ADDENDUM TO THE CONTRACT

Gastineau Elementary School Renovation

Contract No. E11-137

ADDENDUM NO.: TWO

SHEET #
A2.1

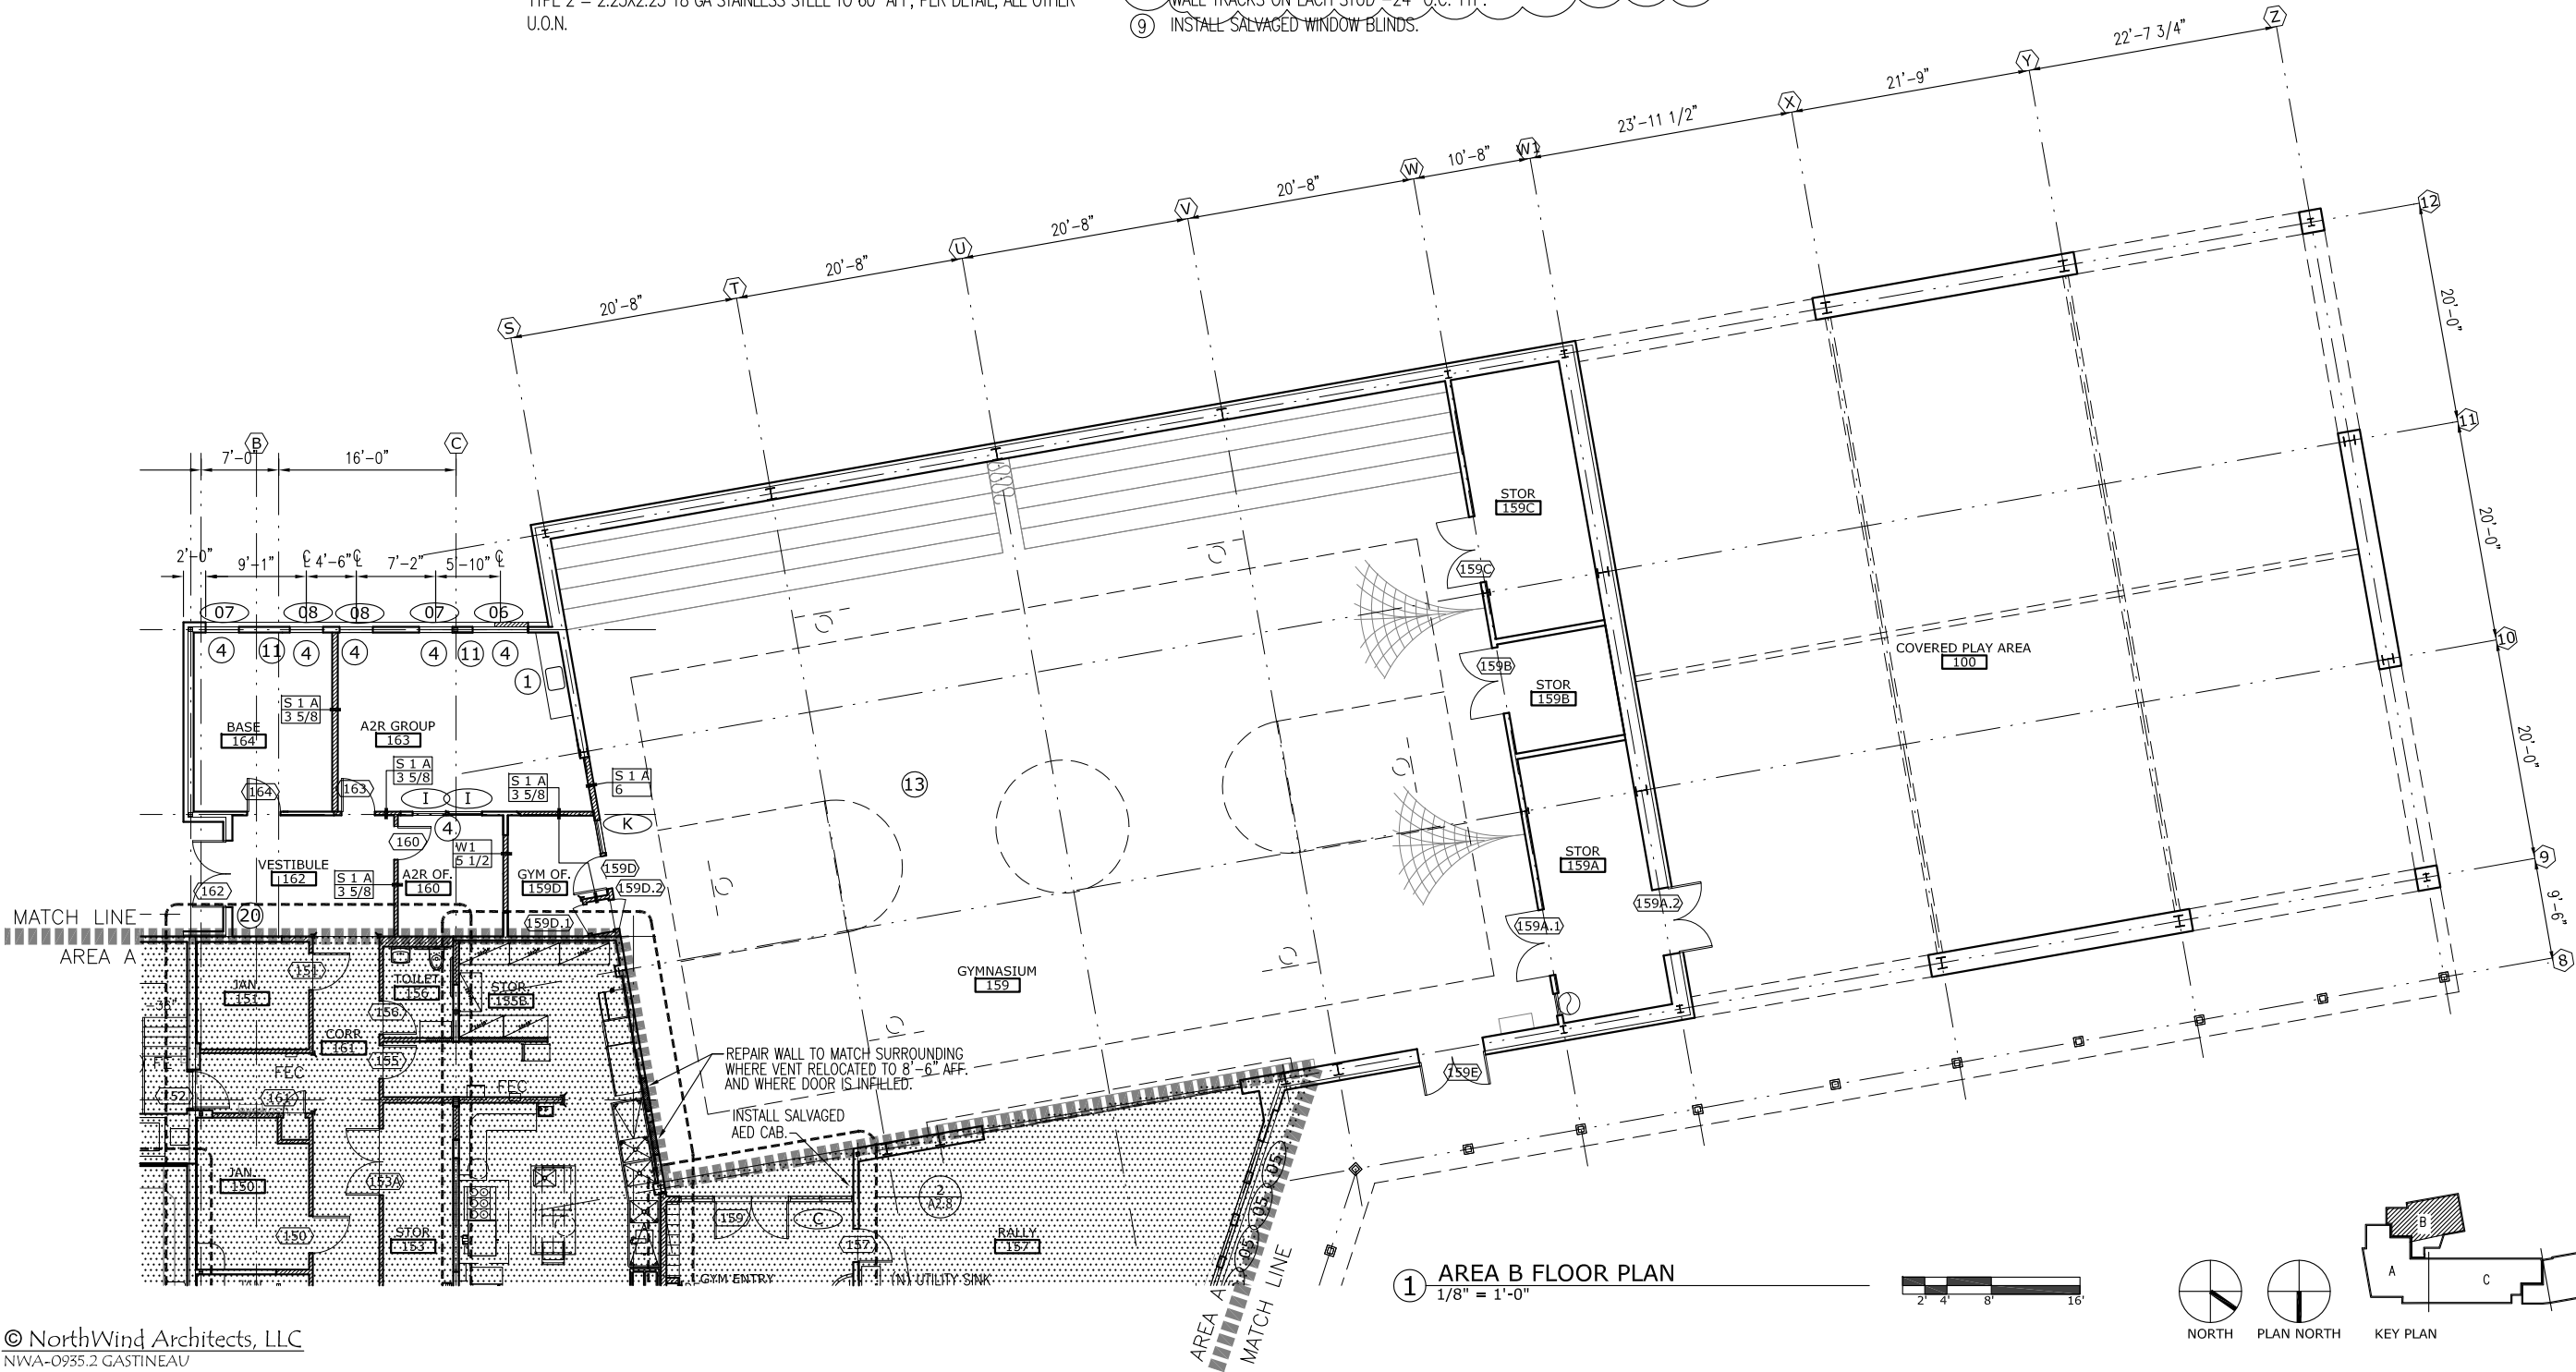
- Item No. 20 A2.1: Delete Sheet A2.1 and replace with attached sheet A2.1. Modifications relate to Key notes 7 and 8. Line-work clarity is improved for half-size drawings.

SHEET #
A2.2

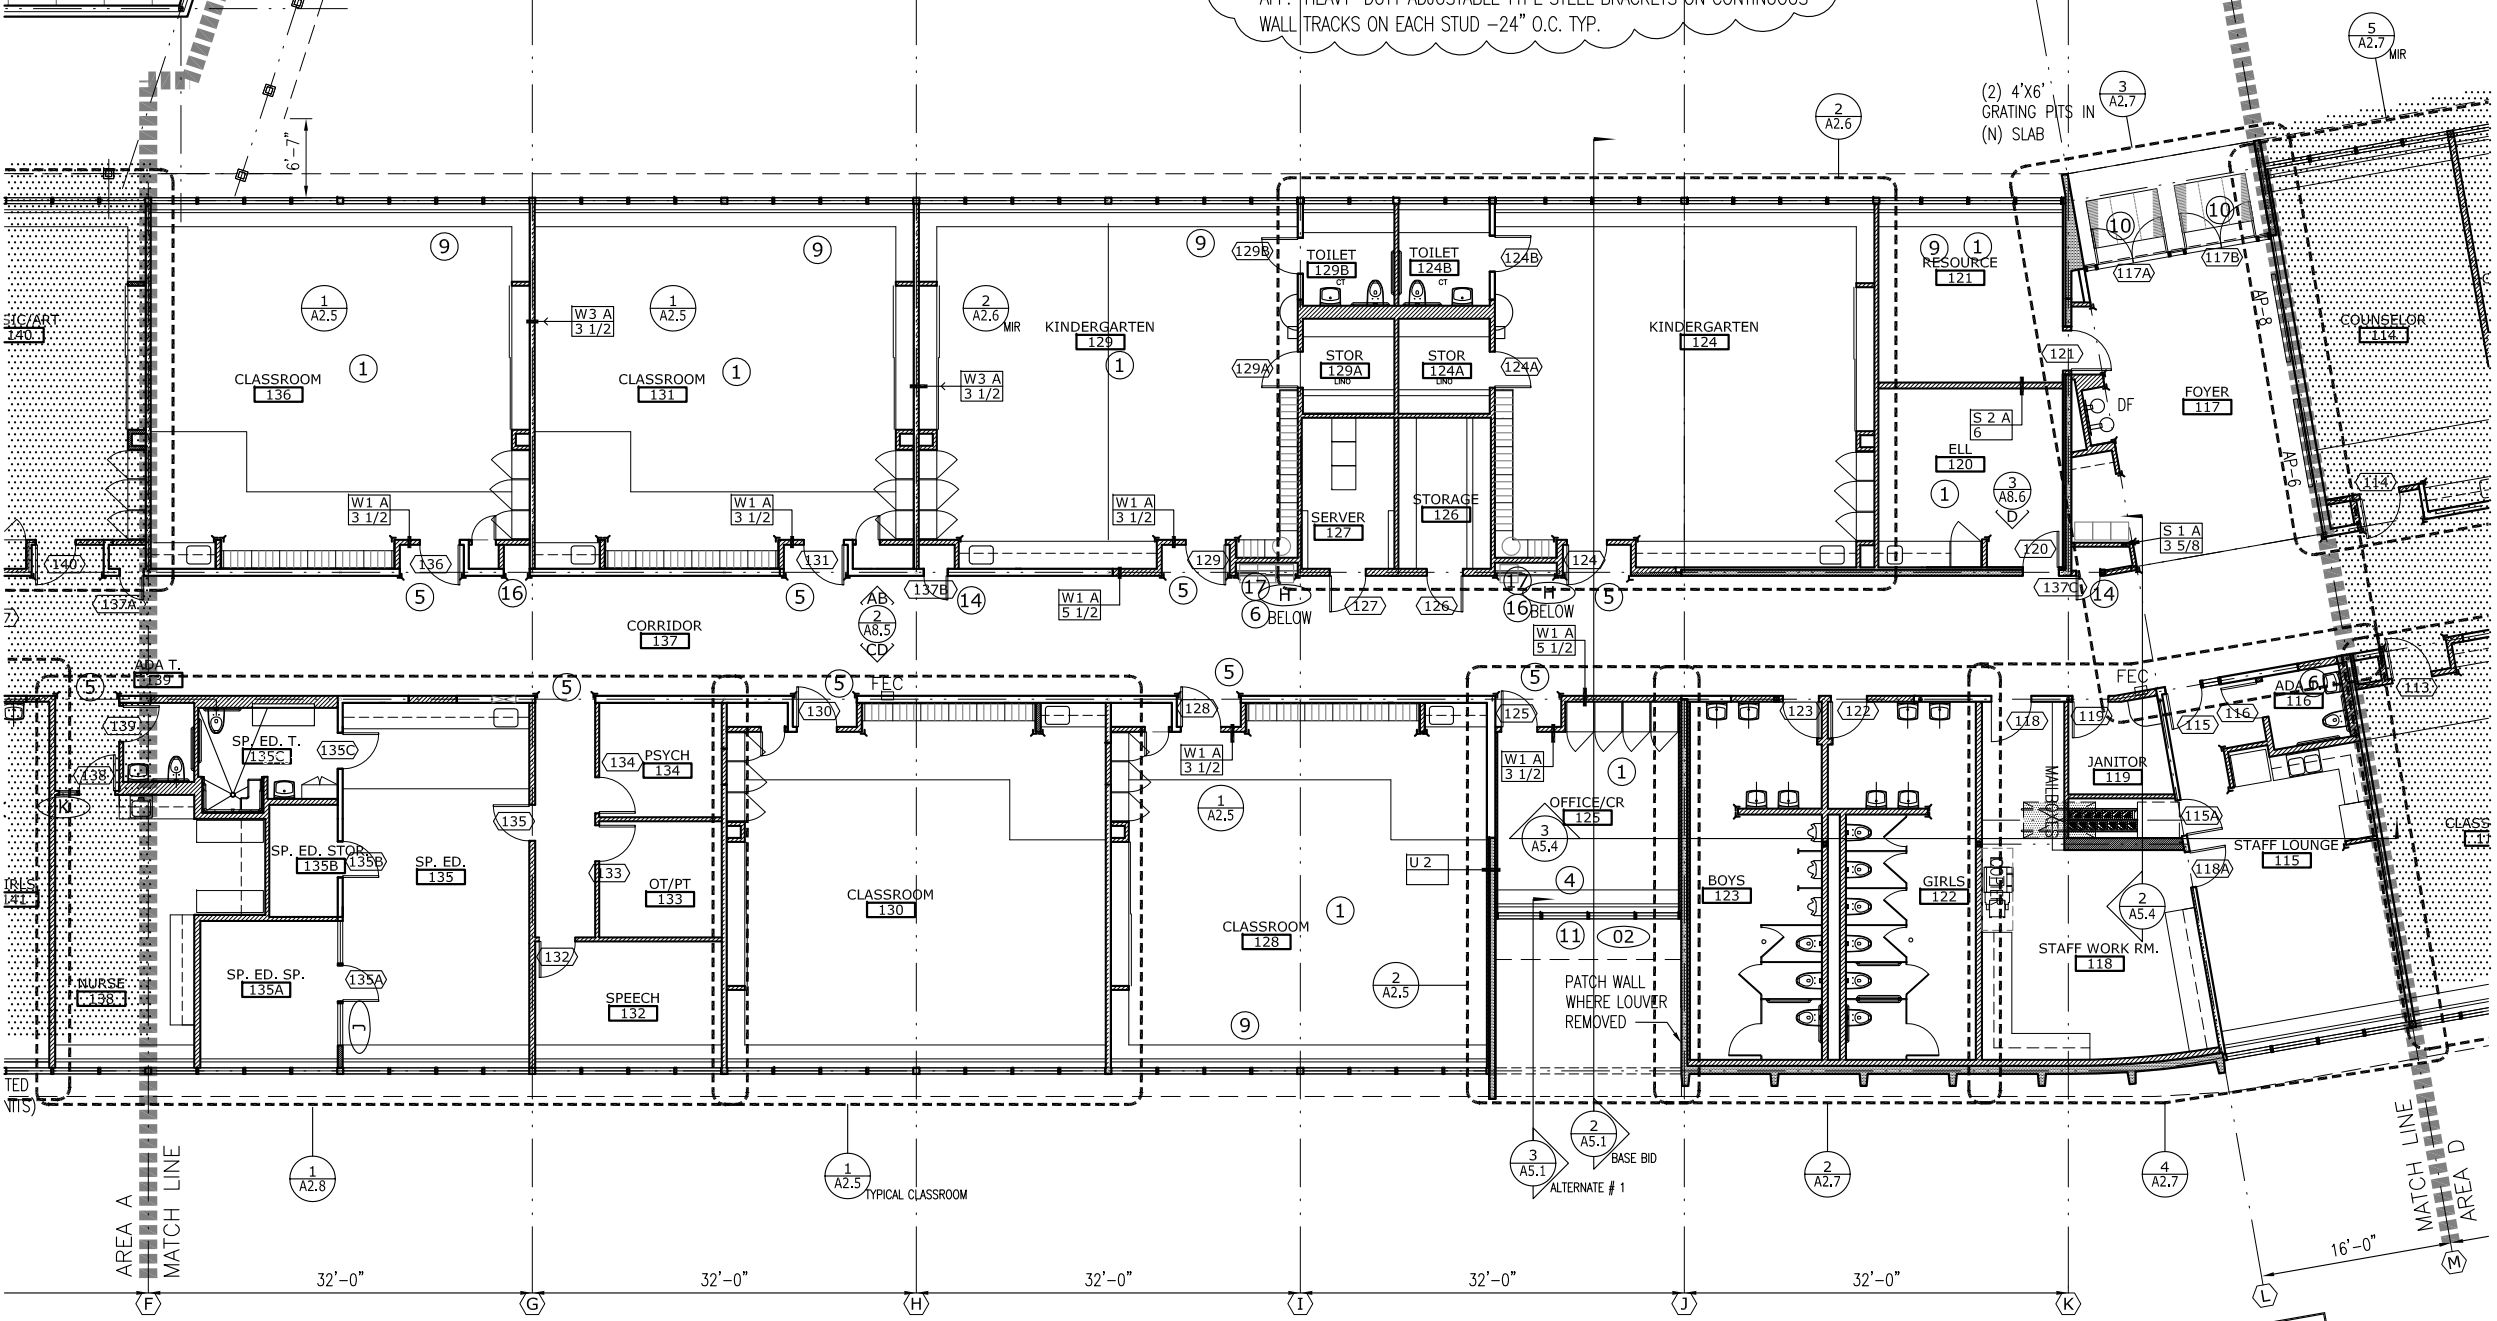
- Item No. 21 A2.2: Delete Sheet A2.2 and replace with attached sheet A2.2. Modifications relate to Key notes 7 and 8. Line-work clarity is improved for half-size drawings.

A2.3

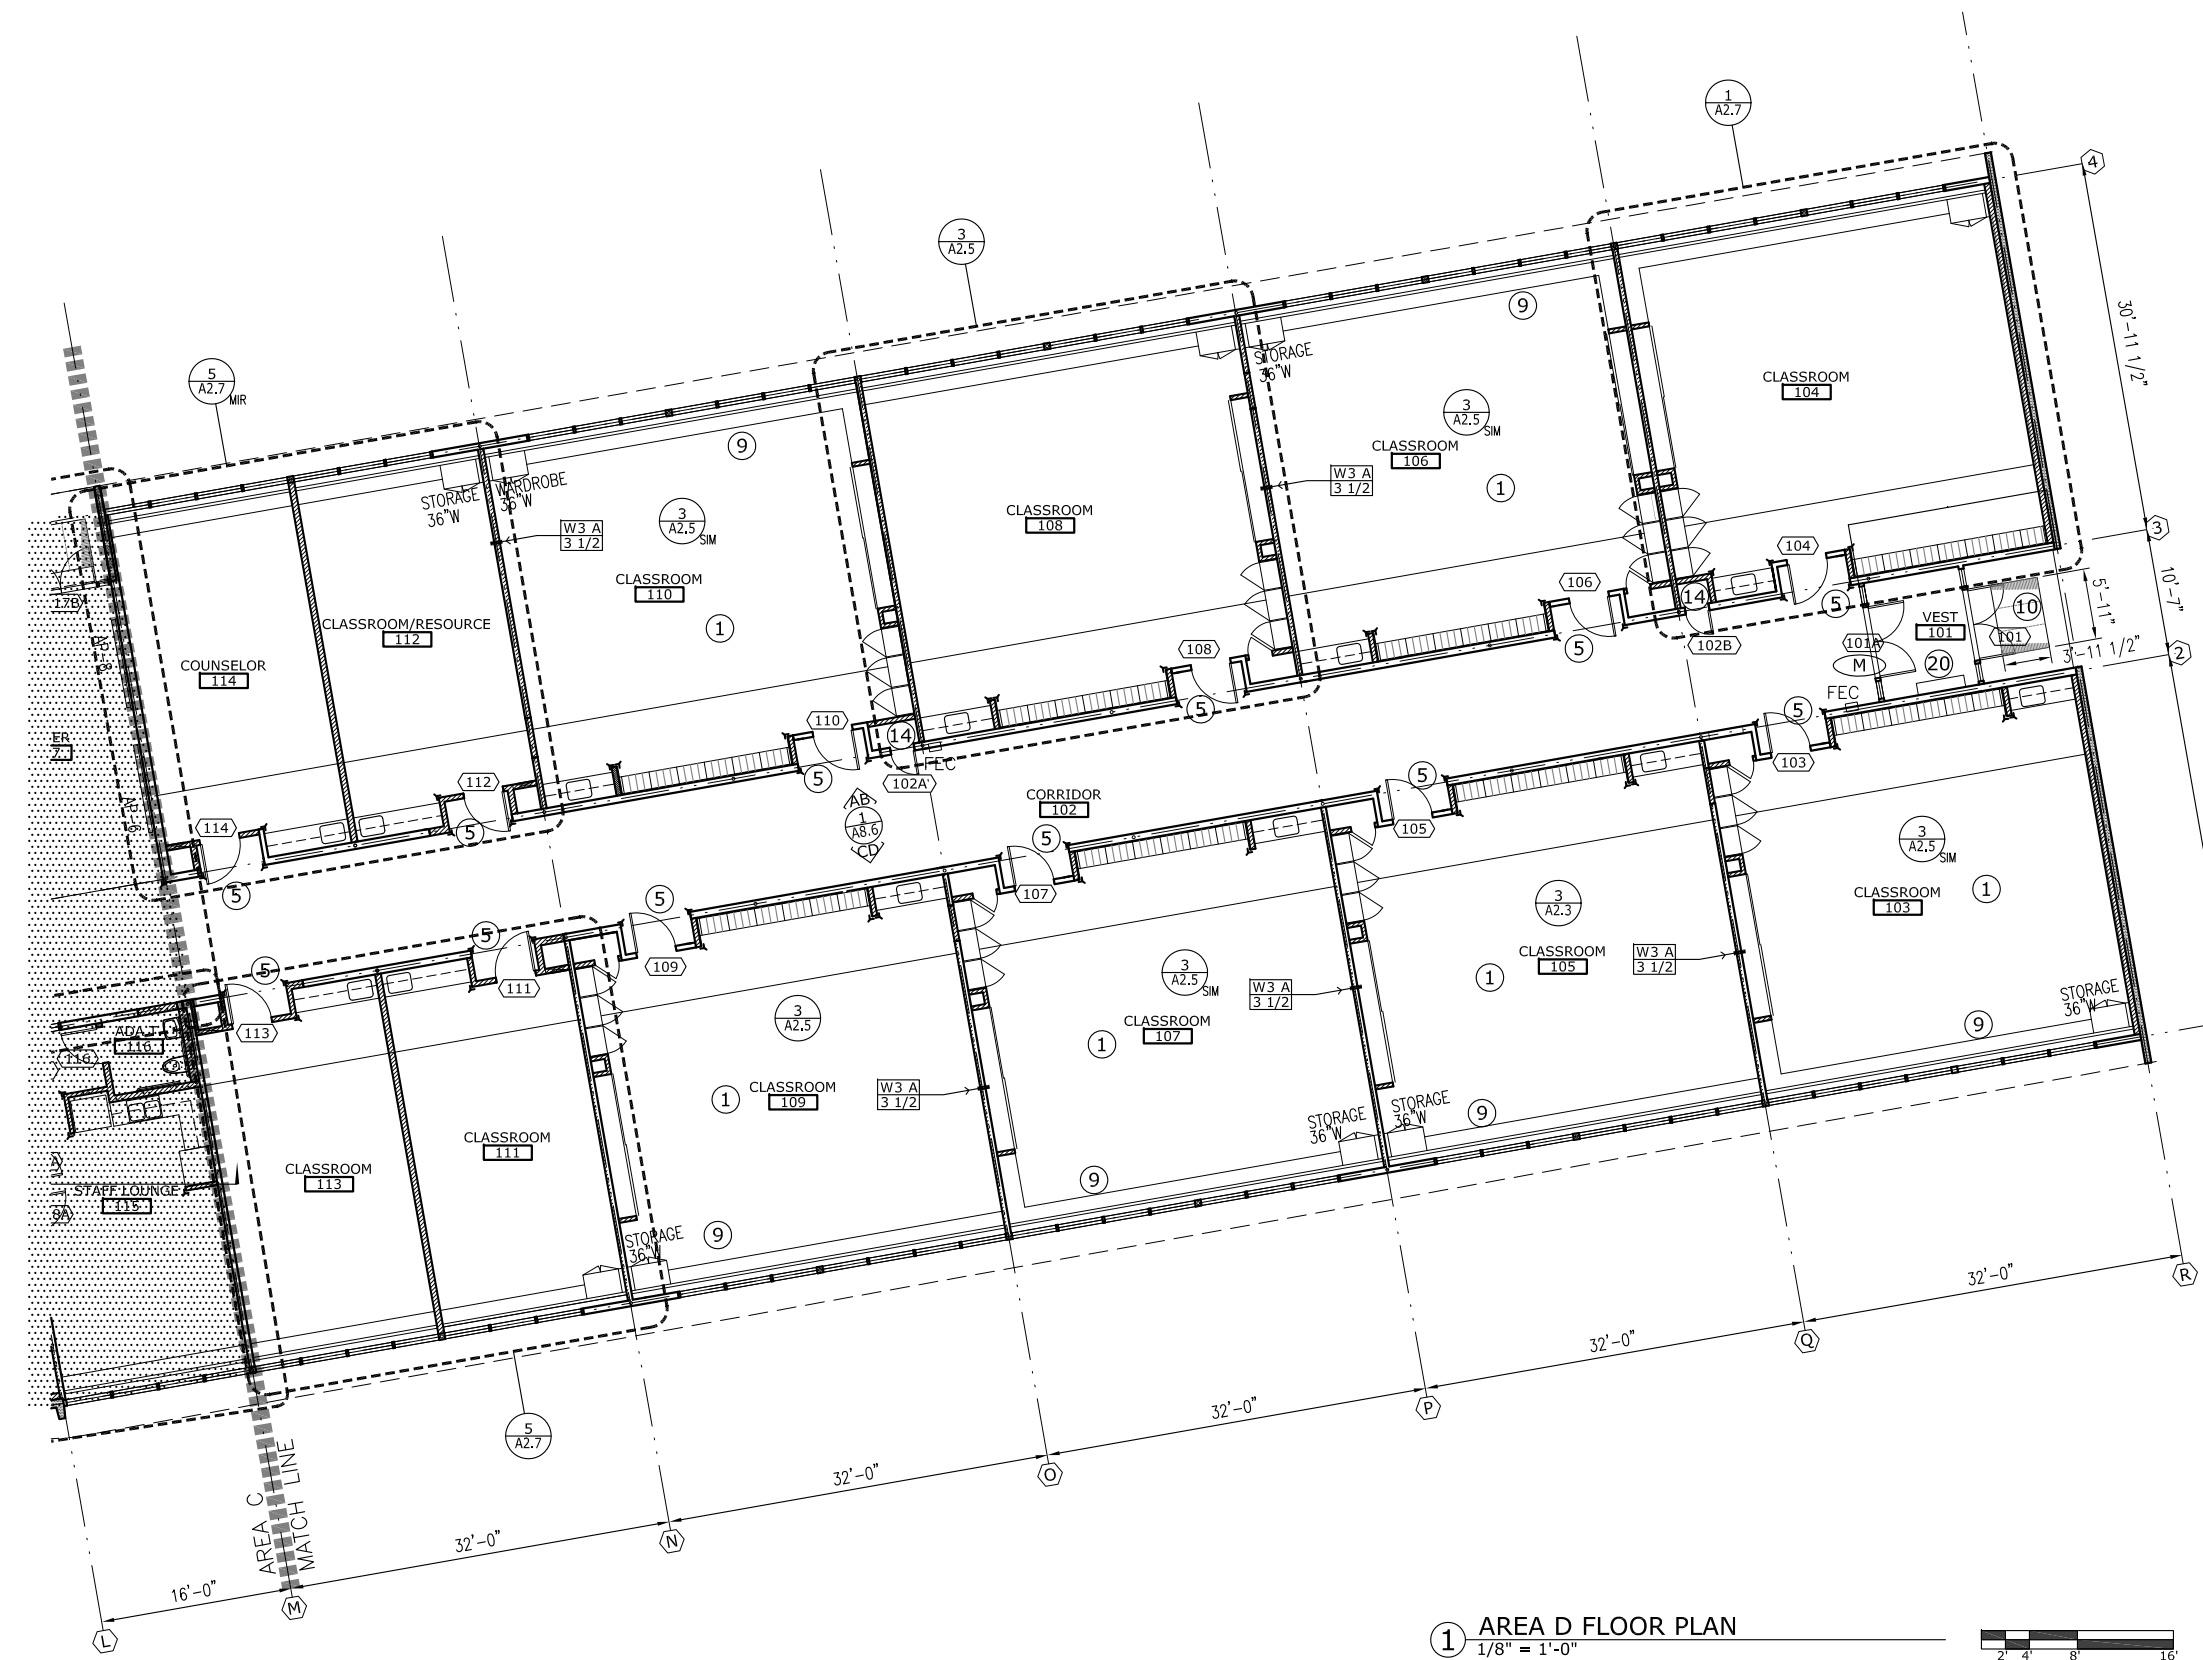
- Item No. 22 A2.3: Delete Sheet A2.3 and replace with attached sheet A2.3. Modifications relate to Key notes 7 and 8. Line-work clarity is improved for half-size drawings.
